CONVAIR

COMMERCIAL CHANGE PROPOSAL

CUSTOMER: Delta Air Lines Inc.

MODEL: 22-2 (Convair "880")

- Enclosures: (A) One copy of Figure 1-1, GENERAL ARRANGEMENT (for information only, figure in Specification will be revised to show leading edge slats on acceptance of this change)
- (B) One copy of Convair Drawing SD-58-03147 - WING L. E. SLAT (for information only)

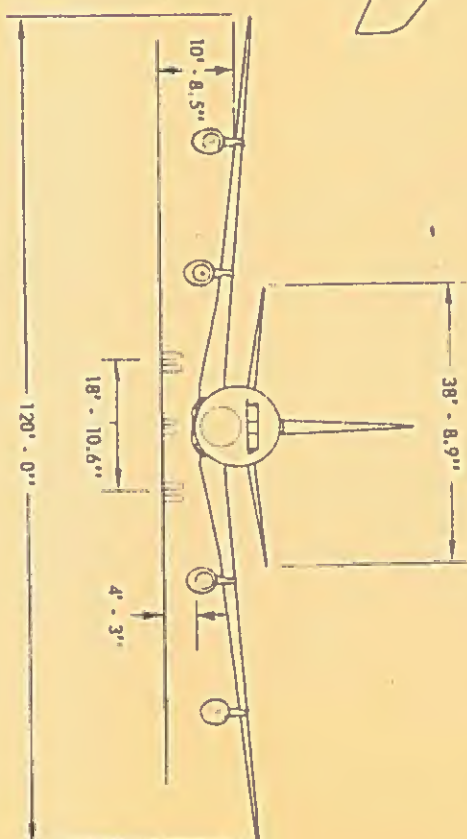
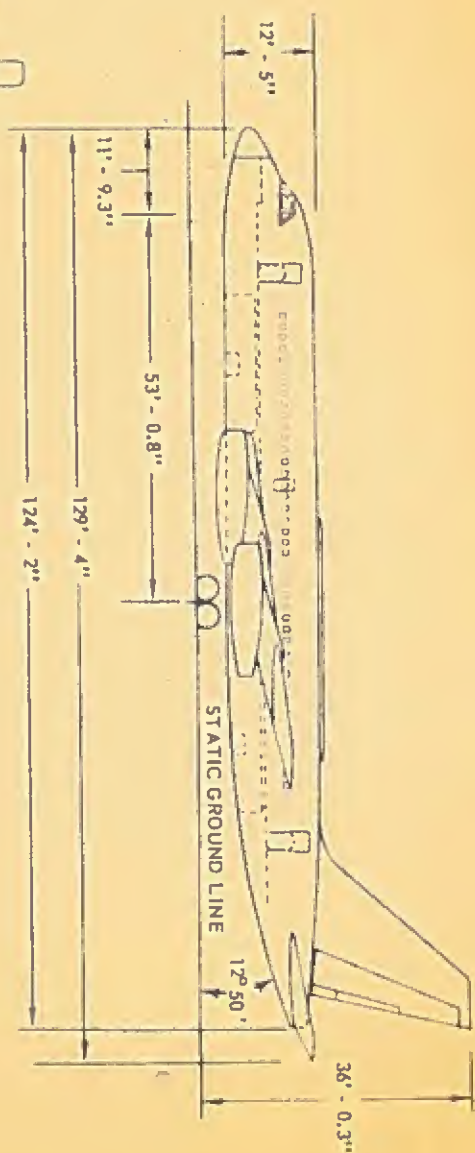
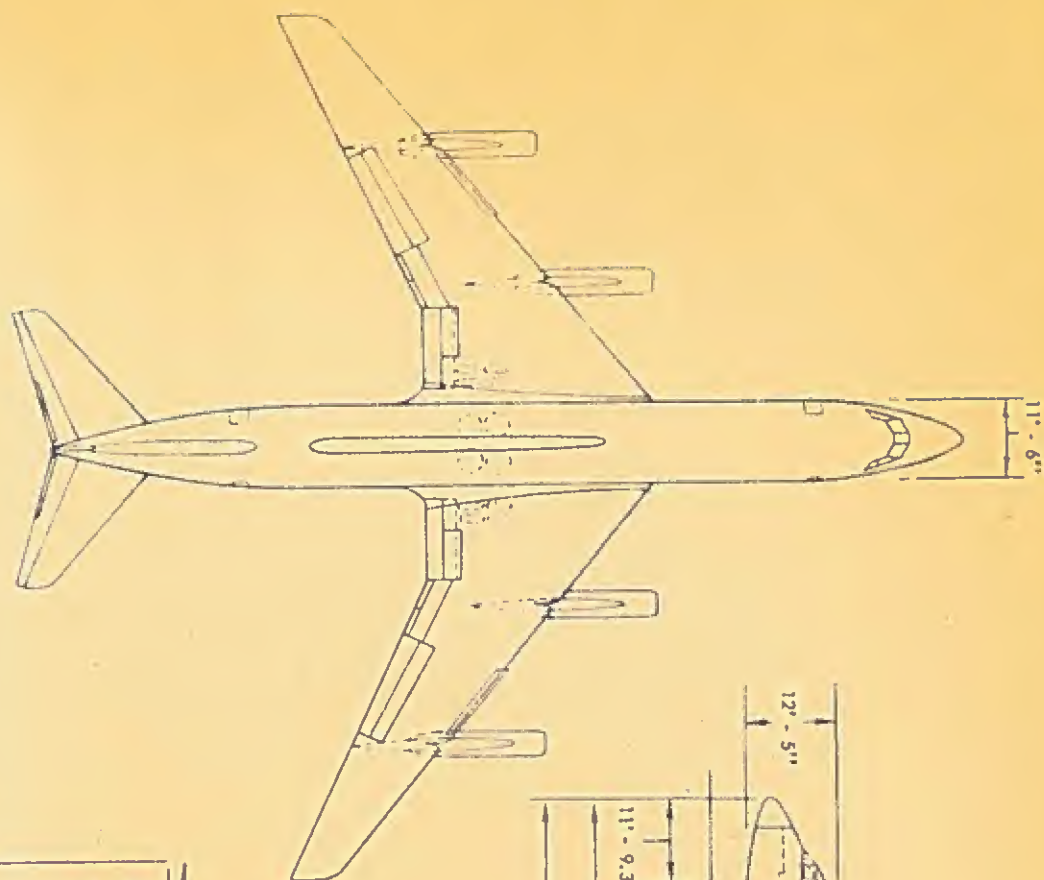
Add the following under paragraph "4. Inherently Interchangeable Parts"

"Leading Edge Slats"

FIGURE 3.14-1

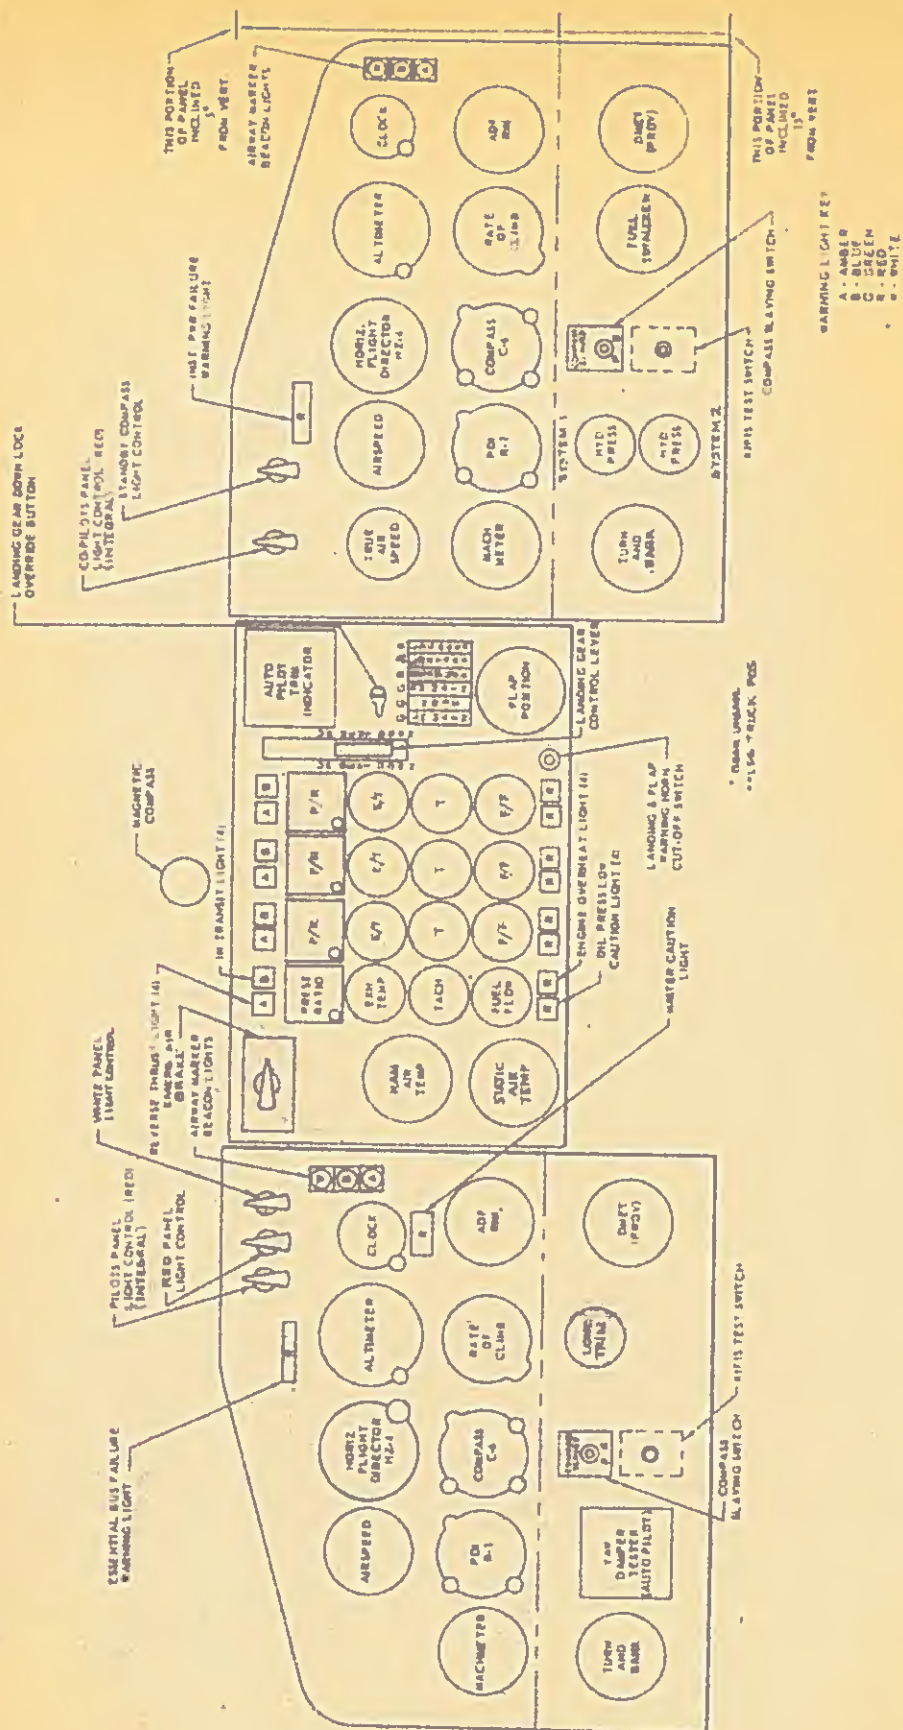
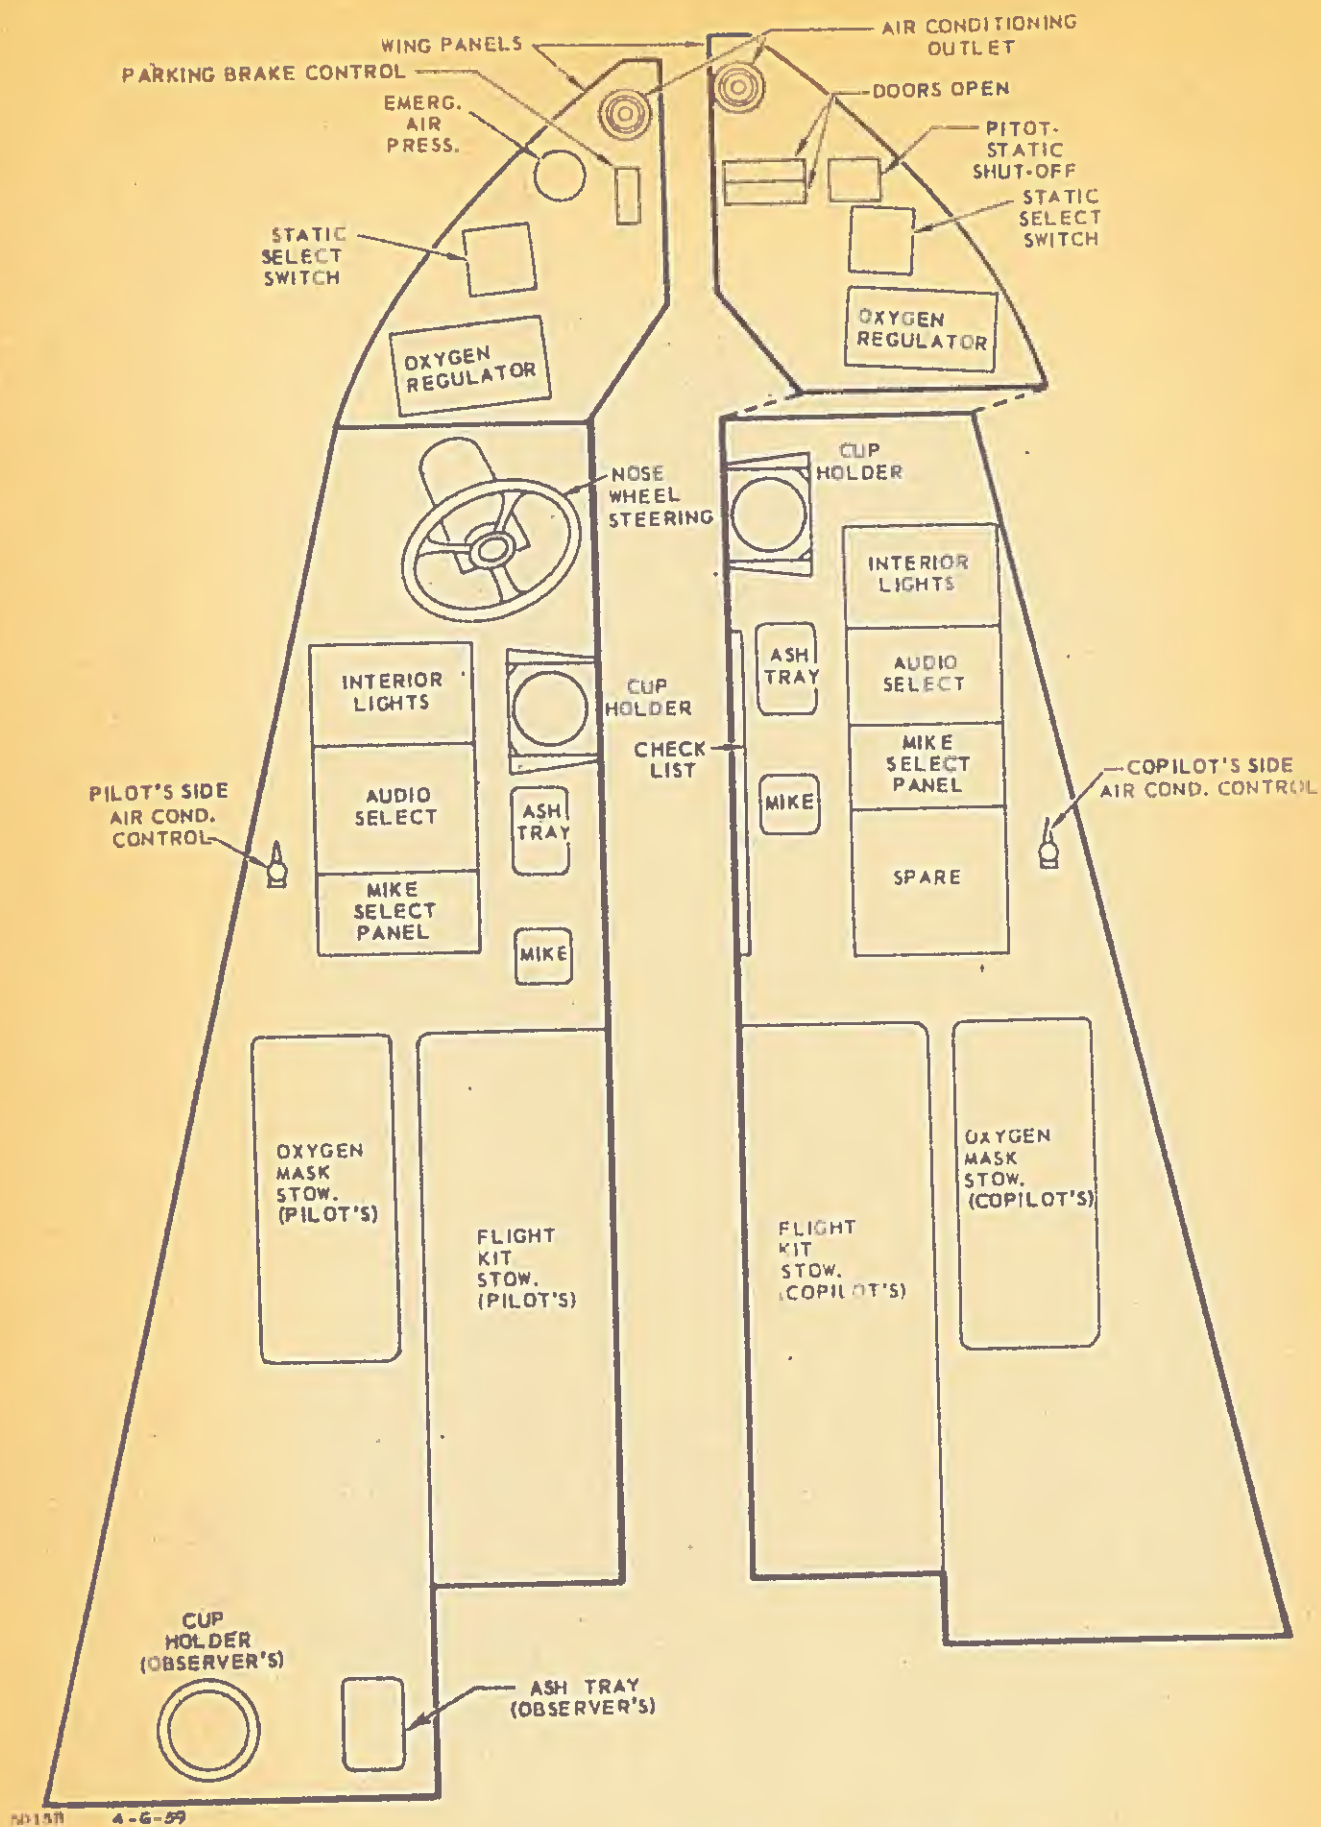
Reason for Change: To improve flexibility of the nose wheel steering and emergency braking

Page 62A, Figure 3.14-1 PILOT'S AND COPILOT'S INSTR. PANELS:
Page 62B, Figure 3.14-2 PILOT AND COPILOT CONSOLE:

"This proposal has no effect on the specification language but relocates the Emergency Air Brake control handle from the pilot's console to the pilot's and copilot's instrument panel and rearranges various other instruments as shown in the attached revised illustrations."

Figure: 3.19-4 - GASEOUS OXYGEN SYSTEM:

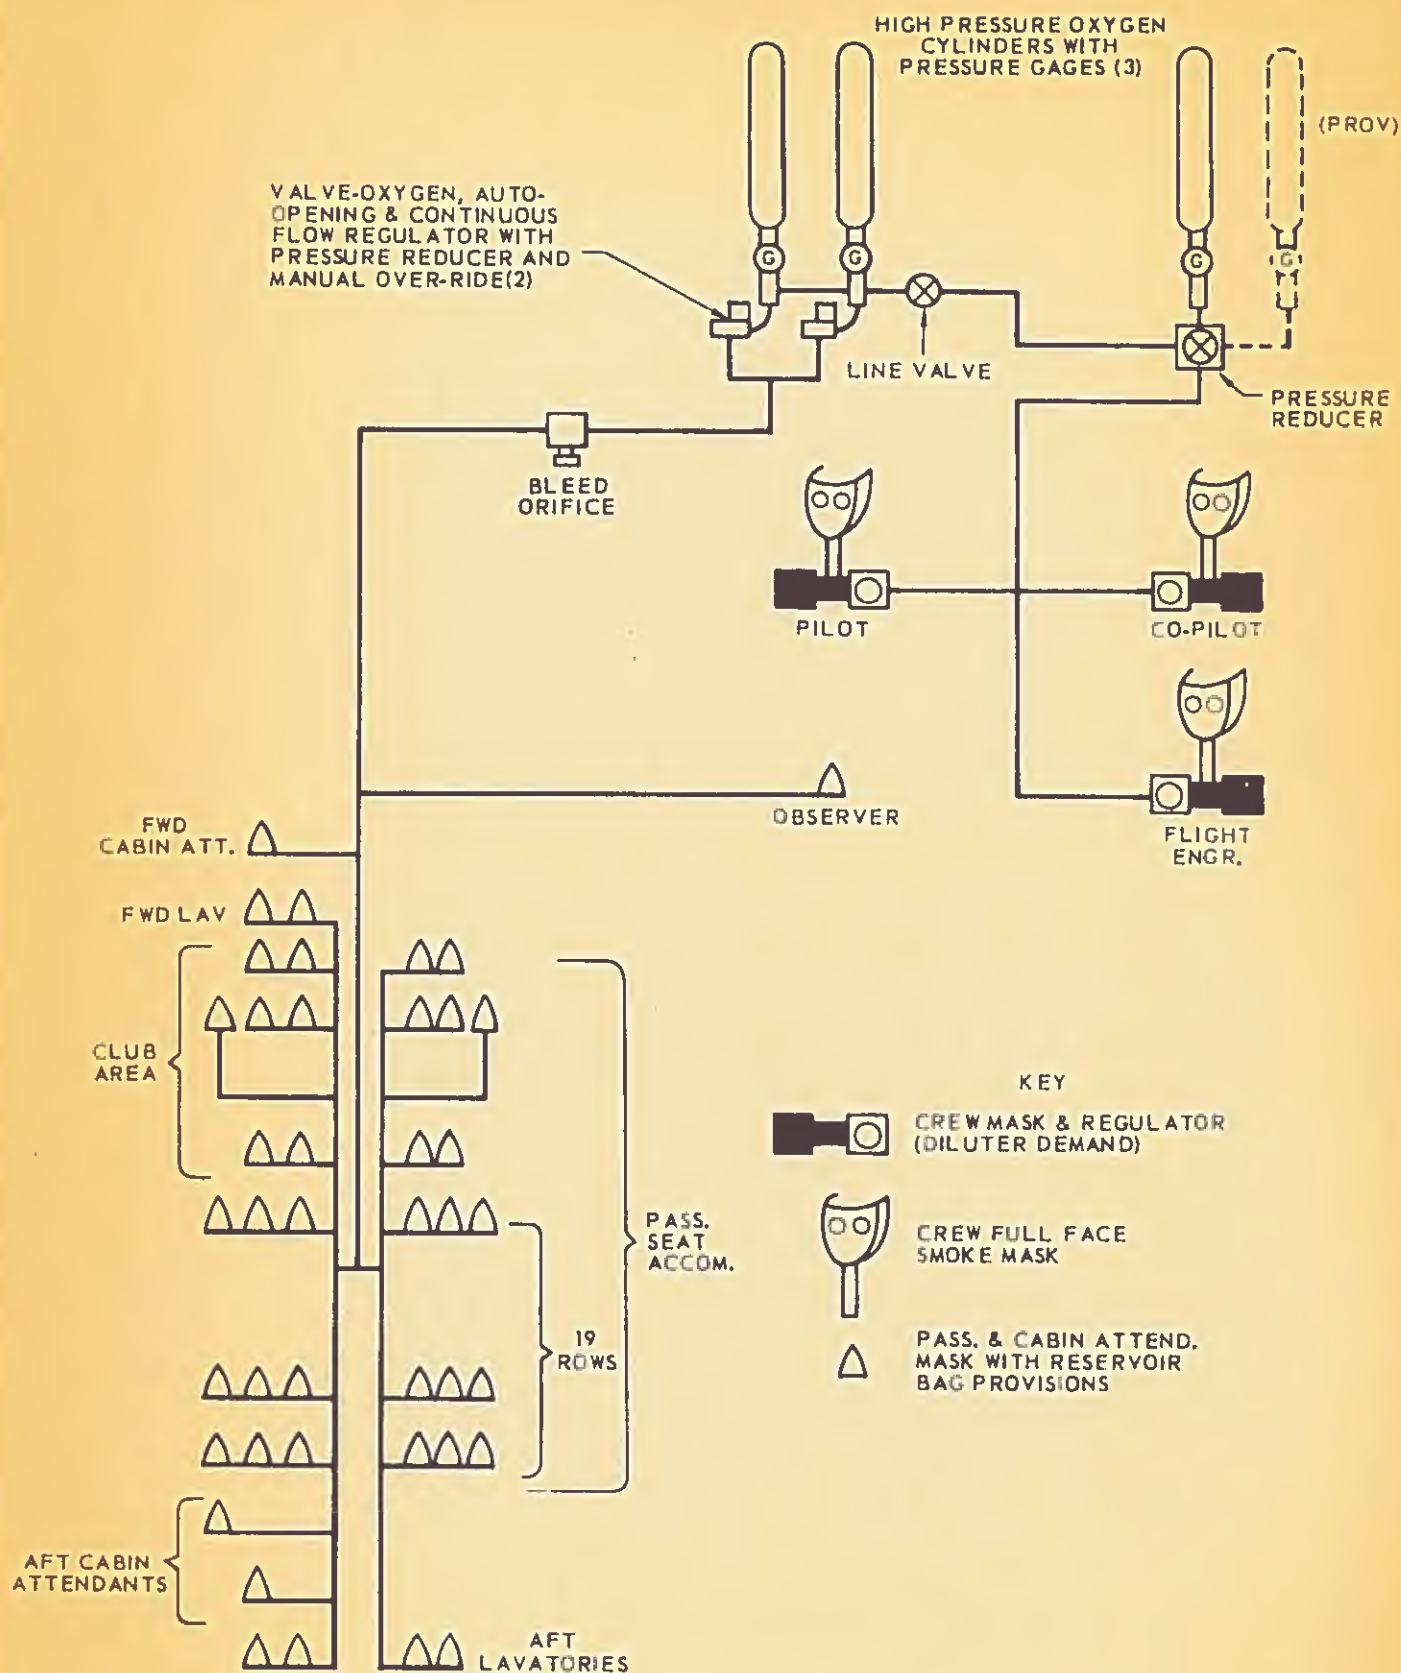
"Provisions for one additional mask shall be made for each seat
row in the main cabin area (three masks for each of the 19 rows
on both sides of the airplane) to provide for emergency oxygen for
children in arms. The oxygen outlet system for the club area shall
be as shown on Figure 3.19-4".

Above figure will be replaced in the specification with Enclosure (A)
on Customer approval of this CCP.

Enclosure (A) One copy of Figure 3.19-4 - GASEOUS OXYGEN SYSTEM

Figure 3.19-3

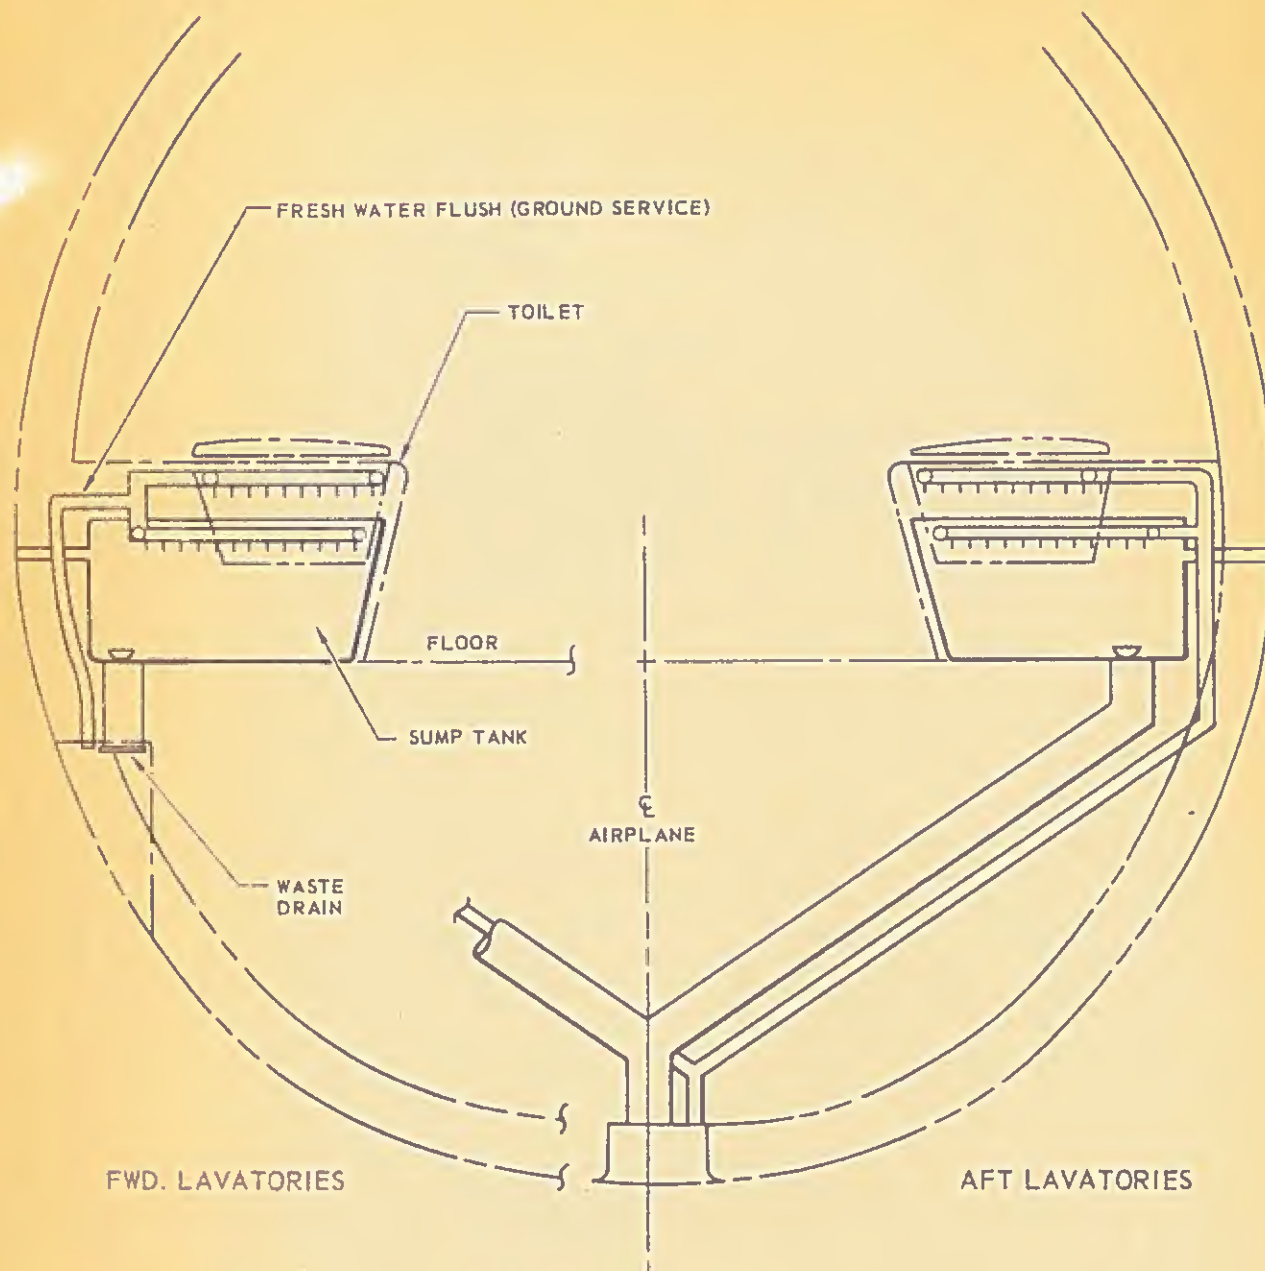
Delete FIGURE 3.19-3 - LAVATORY TOILET WATER SYSTEM SCHEMATIC from Specification and replace with Enclosure (A).

Enclosure: (A) One copy Page 115f - FIGURE 3.19-3 - LAVATORY TOILET WATER SYSTEM SCHEMATIC
